N6761A-02

S E R V I C E N O T E

N6761A Precision DC Power Module

Figure 1. Mainframe is unable to detect Option 2UA

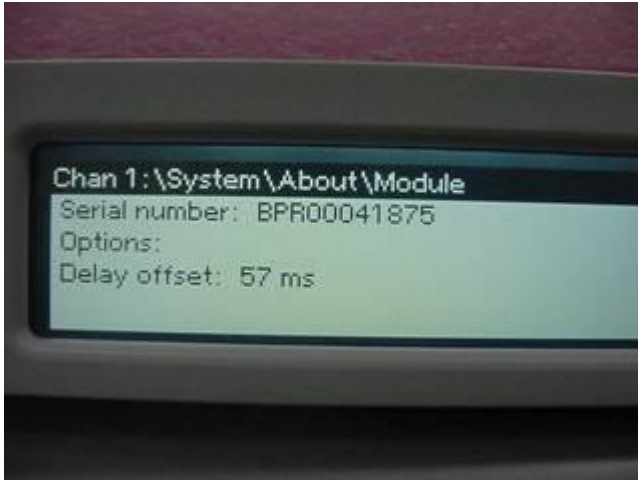
All N6700A, N6700B, N6701A and N6702A mainframes with a firmware revision lower than C.02.18 have the potential to not detect the 2UA Option during a query for the option information from the mainframe's menu as well as using the SCPI command SYST:CHAN:OPT? (@<chanlist>).

First, check the firmware revision of the N6700A, N6700B, N6701A or N6702A mainframe. To do this using one of the IO interfaces, send the “*IDN?” query.

Menu -> System -> About -> Frame. It will be listed under “Firmware revision.” If the firmware revision is C.02.18 or higher, the unit has already been upgraded and no further upgrade is required.

If the firmware revision is older than C.02.18 then the firmware must be upgraded. All files, programs, and instructions required to upgrade the firmware are located at the following website:
